DEVIATION REQUEST AND DECISION FORM

Project Name : Waterbury

Deviation Exhibits

Deviation Exhibit No 1 Saybrook Drive Deviation Request Location

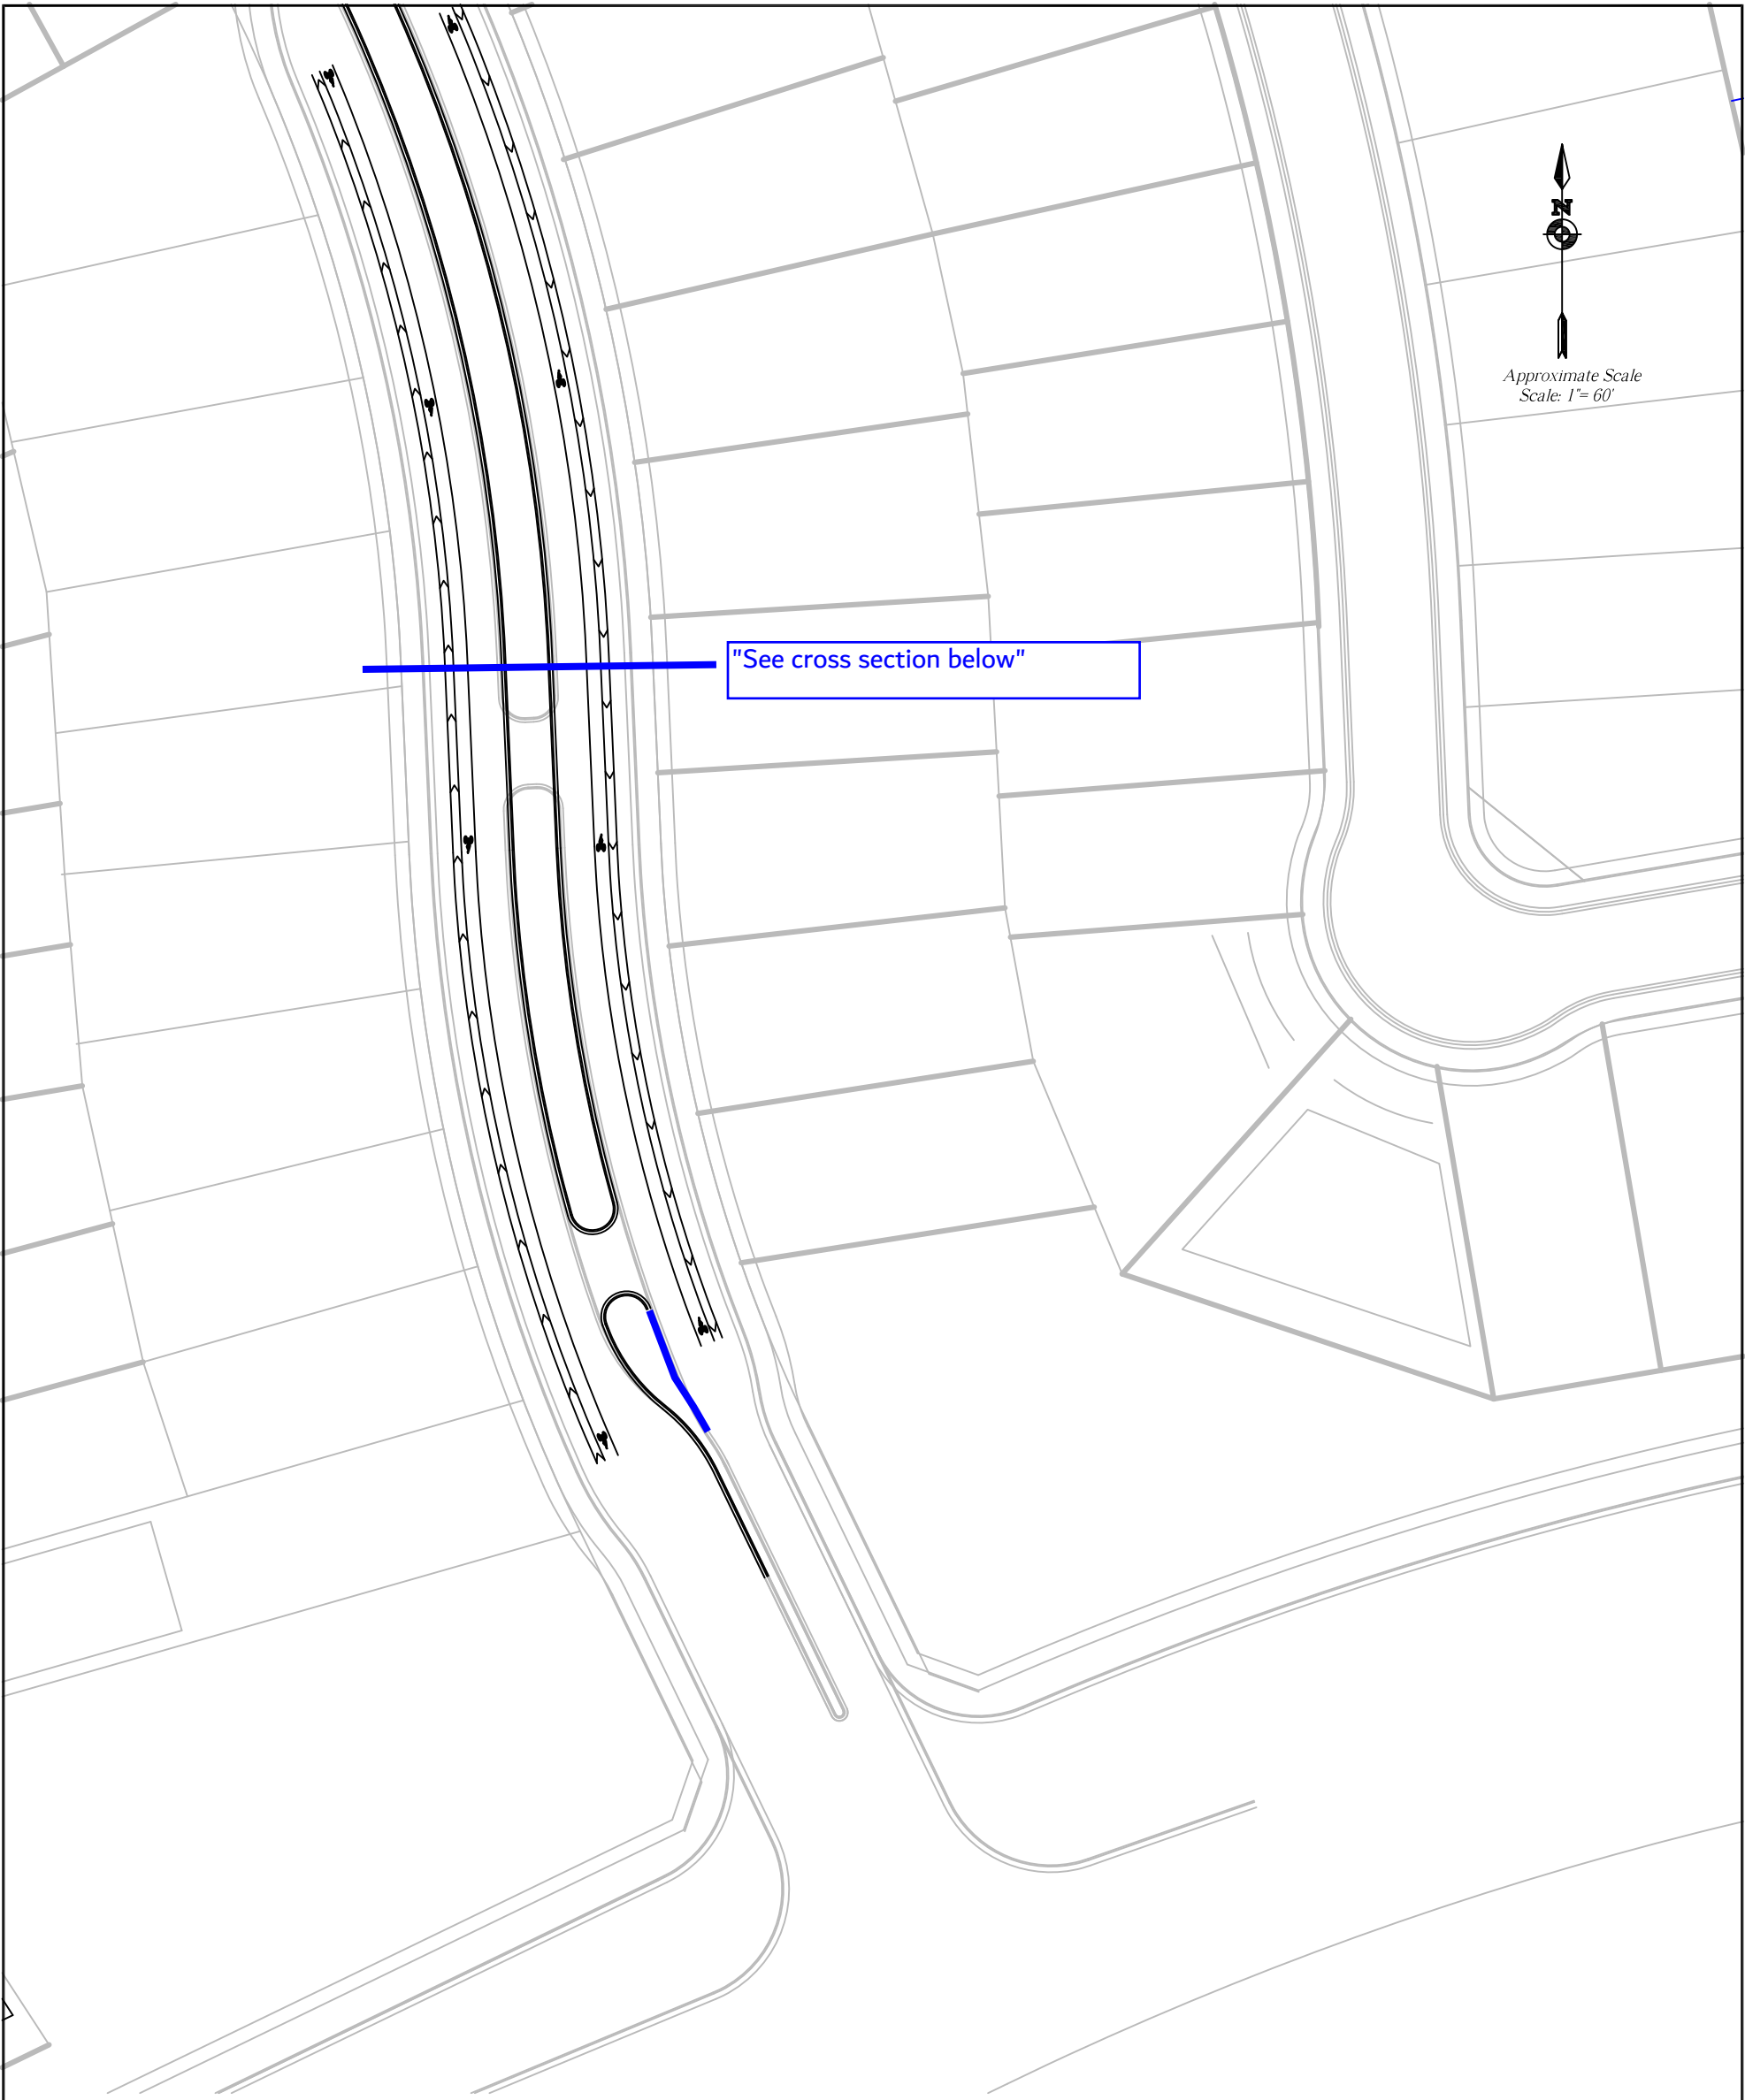
The deviation will allow for partial turn movement direct access for lots adjacent to Saybrook Drive (a planned Urban Collector) as no local or private roadways or alleys would provide access.

Direct access to Saybrook Drive is needed as there would be no other local or private streets or alleys adjacent to these lots.

The proposed median will restrict the driveways for lots adjacent to Saybrook Drive to right-in/right-out only. Residents & guests will be able to utilize the planned roundabout to the north and the proposed median opening on the south end to make U-turns to travel in the desired direction. The proposed parking lane and 3' buffer between the parking lane and the bike lane will allow for vehicles to safely back out of their driveways without the need to back into the bike lane or travel lane.

Deviation Exhibit 2
Saybrook Drive
Cross Section
Waterbury (LSC #204220)

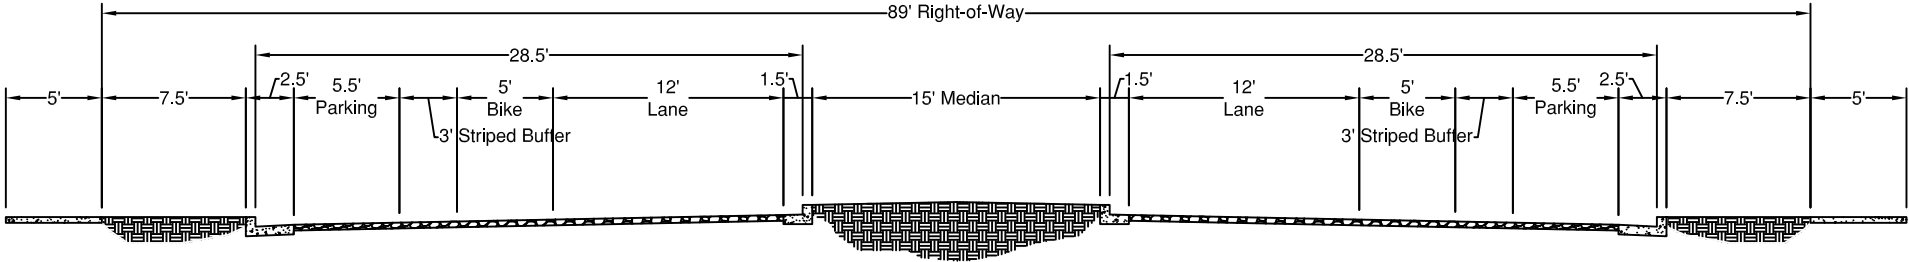
See the attached exhibit for the proposed modified cross section for Saybrook Drive.

The typical cross section for an Urban Residential Collector provides for a 36' of pavement (excluding gutter pan) in 60' of right-of-way with no median.

The proposed cross section would provide for 25.5' of pavement in each direction (7.5' for parking including gutter pan, a 3' striped "buffer", a 5' bike lane, a 12' travel lane (exclusive of 1' concrete gutter plan) and a 15' median in 89' of right-of-way.

The proposed cross section will provide for on street parallel parking which is not allowed on Urban Residential Collectors based on the criteria contained in Table 2-6. The adjacent parking lane and striped buffer would provide space for drivers to back out of driveways without having to back into the through traffic lanes. The intention is that parking would be restricted in front of the driveways (obviously) and "upstream" a short distance from each driveway to allow for backing maneuver into the combined buffer and parking lane width.
